RESTAURANT KITCHEN FIT-OUT

PROPOSED LAYOUT

Kitchen Equipment Rearrangement — Option A

Ground floor kitchen — assessment of the existing layout (A-01) and the proposed rearrangement (A-02)

PROPOSED GROUND FLOOR LAYOUT

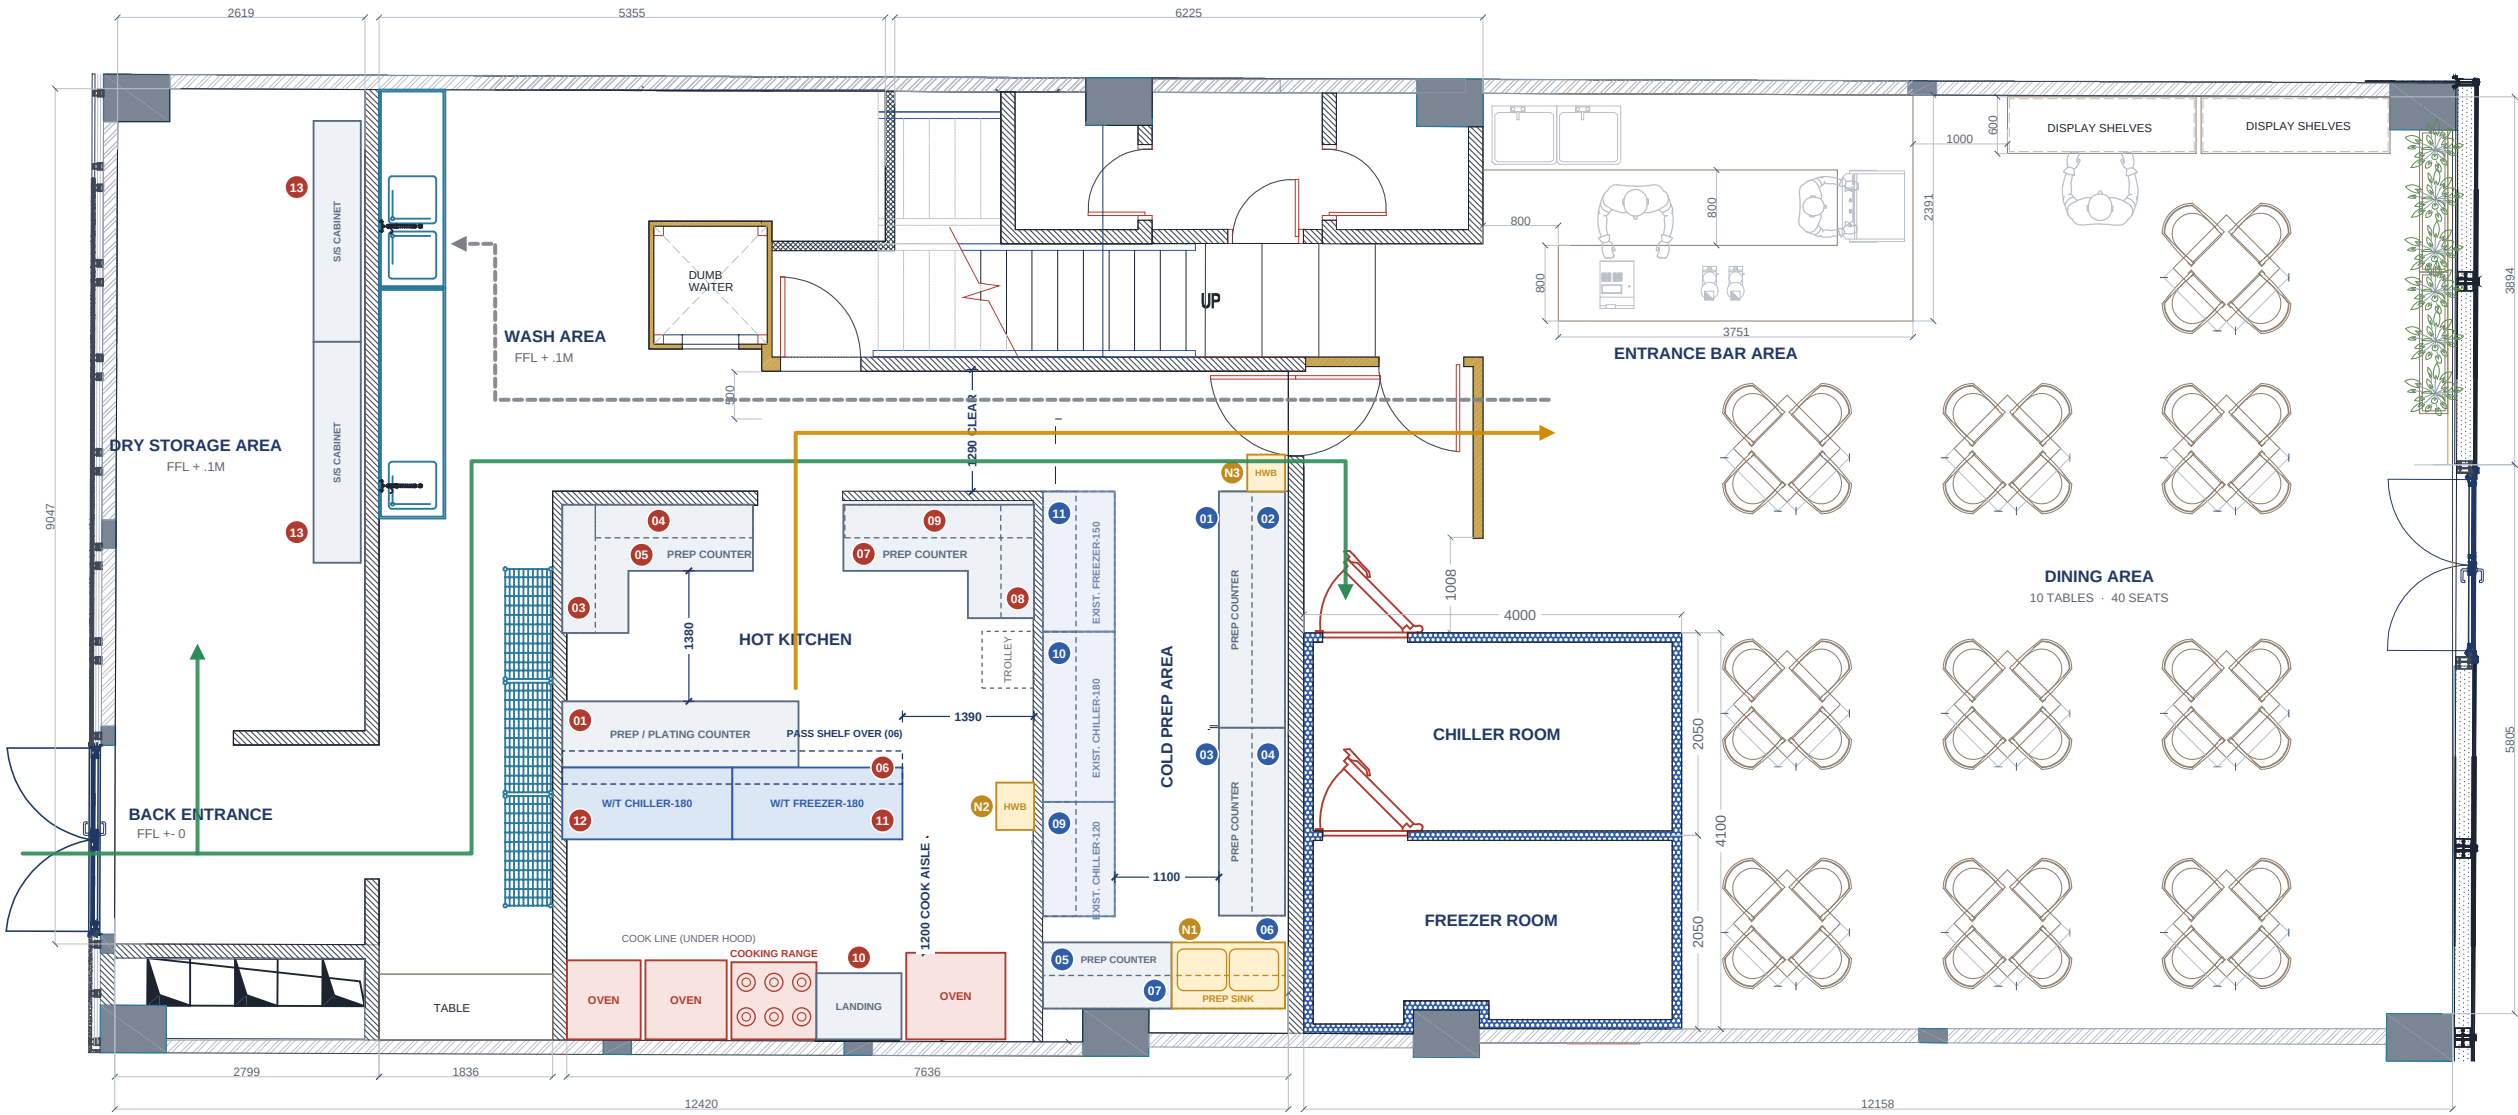
- Centre island removed. W/T chiller & freezer now form a chef base opposite the range with a 1200 mm cook aisle.
- Peninsula carries a pass shelf (06) so plated food leaves via the north aisle without crossing the cook line.
- Range moved 850 mm left, trolley out of the line, 900 mm landing table (10) added.
- Prep zone separated from cooking: 1380 mm prep aisle, 1390 mm clear route from door to cook line.
- Corridor cabinets (13) moved to dry store: corridor widens 800 → 1290 mm.
- Prep sink N1 and hand wash basins N2 / N3 added (MEP to confirm).

Location	Existing	Proposed
Cook aisle	1140	1200
Door to cook line	1000	1390
Hot prep aisle	1016	1380
Corridor	800	1290

BEFORE vs AFTER

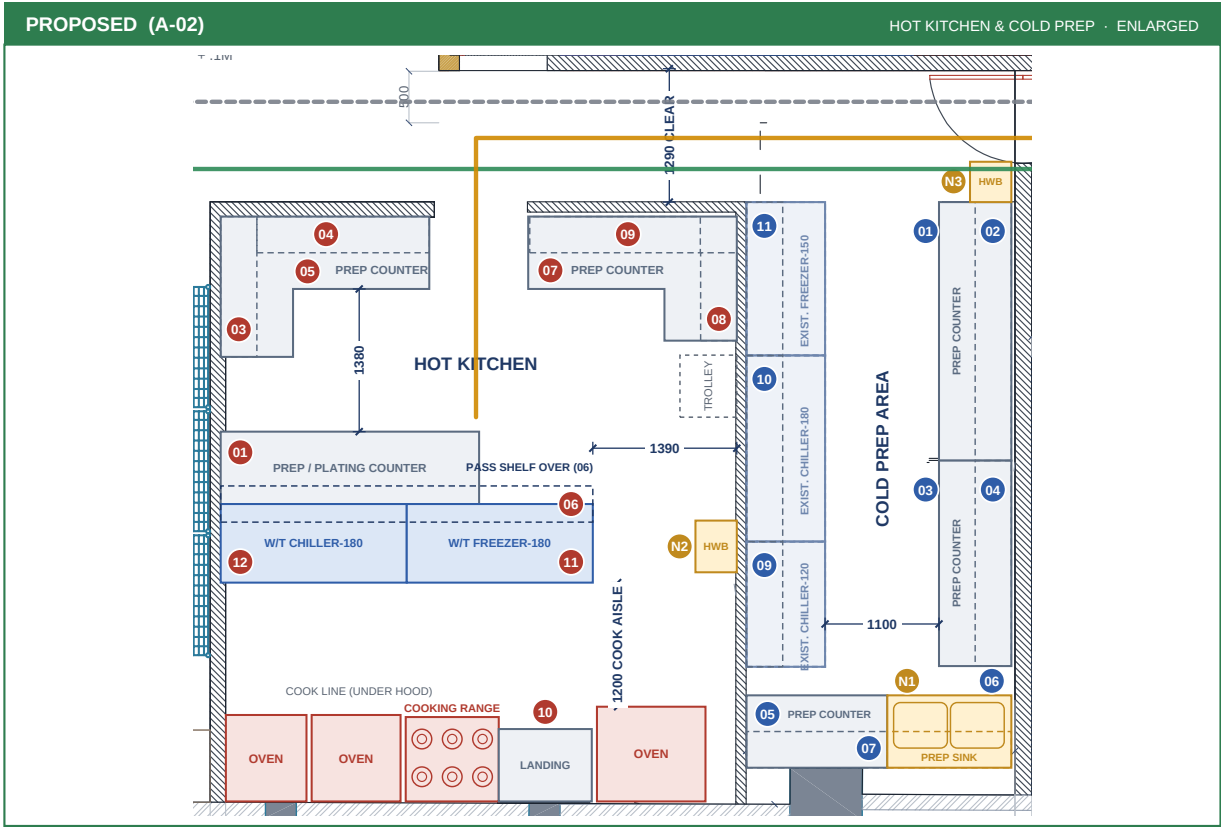
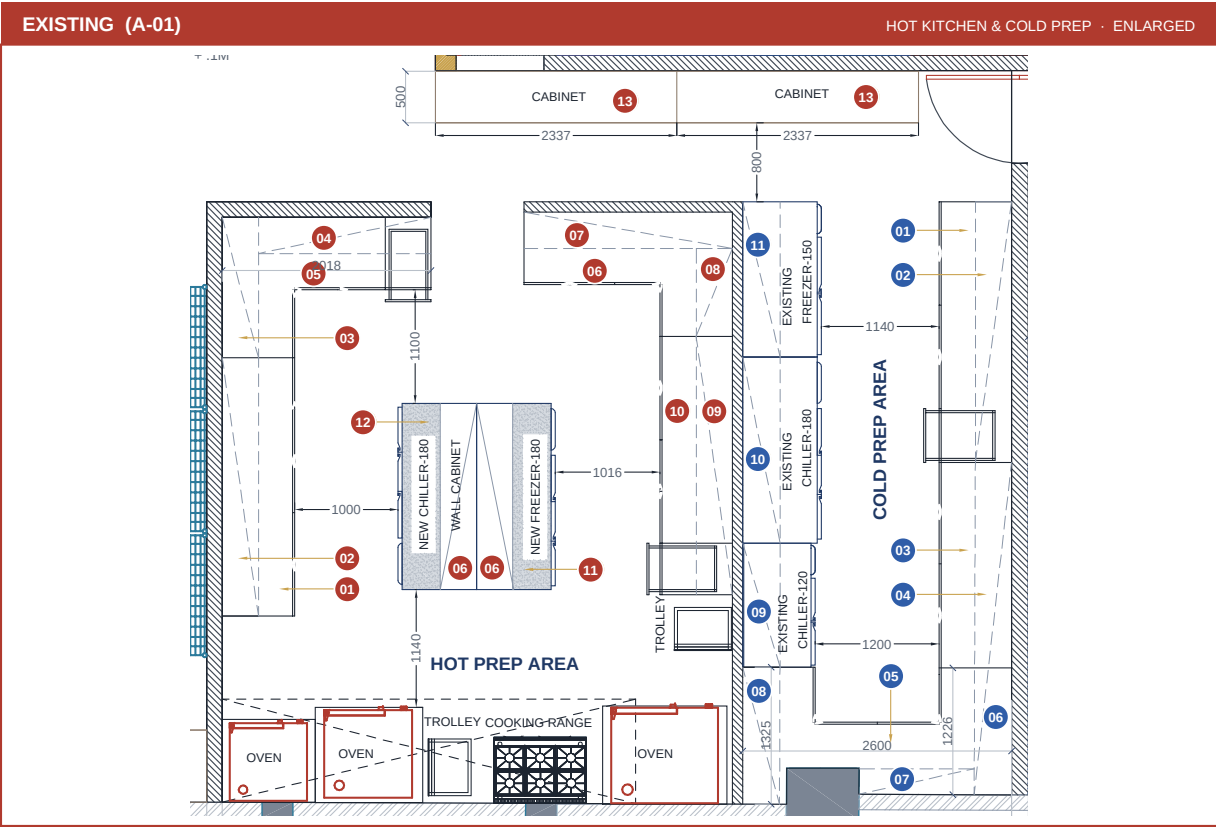
#	AREA	FINDING	RISK	RESPONSE IN PROPOSED LAYOUT (A-02)
1	HOT KITCHEN	Centre island (chiller / wall cabinet / freezer) leaves side aisles of only 1000–1016 mm; the only route from the door to the cook line runs through them.	HIGH	Island removed. Refrigeration becomes a chef base on a peninsula; 1390 mm clear route from door to line.
2	HOT KITCHEN	Aisle between island and cook line is 1140 mm with oven doors opening into it.	MED	Chef base set at a 1200 mm cook aisle; cook turns 180° from range to W/T chiller / freezer.
3	COOK LINE	Trolley parked mid-line between oven and range; no landing space beside the range for pans or plates.	MED	Trolley moved to a trolley bay. Range moved 850 mm; 900 mm landing table (10) added.
4	HOT KITCHEN	No hand wash basin in the hot kitchen or cold prep.	HIGH	Hand wash basins N2 (hot kitchen) and N3 (cold prep entry) added.
5	COLD PREP	No sink for washing vegetables or thawing; raw produce must be carried to the wash area and back.	HIGH	Right return of C-shape counter replaced with a 1200 mm double bowl prep sink N1 on the outside wall.

6	CORRIDOR	Cabinets 13 (2 × 2337 × 500) cut the only circulation corridor to 800 mm; goods, service and dirty returns all share it.	HIGH	Cabinets moved to dry store; corridor clear width 1290 mm.
7	SERVICE	No defined pass: plated food is carried across the kitchen to the door.	MED	Pass shelf 06 on the peninsula, next to the door route; servers stay out of the cook aisle.
8	FABRICATION	Hot kitchen has ~11.6 m of prep counter plus over shelves; item 07 is described as an over shelf but sized as a base cabinet.	LOW	Hot prep counter cut to ~9.1 m + 0.9 m landing; two over shelves omitted. Confirm item 07.

MEASURE	EXISTING (A-01)	PROPOSED (A-02)
Cook aisle (range ↔ refrigeration)	1140 mm	1200 mm
Door → cook line route	1000 mm	1390 mm
Hot kitchen prep aisle	1000 / 1016 mm	1380 mm
Main corridor clear width	800 mm	1290 mm
Hand wash basins	0	2
Prep sink in cold prep	None	1 × double bowl
Landing beside range	None	900 mm
Hot kitchen S/S prep counter	~11.6 m	~9.1 m + landing

- ☐ Hood canopy covers the full cook line in its new order, with 150 mm overhang each end.
- ☐ Gas and power for the range moved ~850 mm left; oven power points stay close to where they are now.
- ☐ Floor boxes / power under the peninsula for the W/T chiller & freezer (2 × dedicated 13 A).
- ☐ Drainage & hot/cold water for prep sink N1 (outside wall) and hand wash basins N2, N3.
- ☐ Pass shelf gantry fixings on the peninsula; height 450 mm above worktop.
- ☐ Dry store wall can carry the relocated cabinets 13; check dry store door swing.
- ☐ Confirm item 07 (hot) description with the client before ordering.
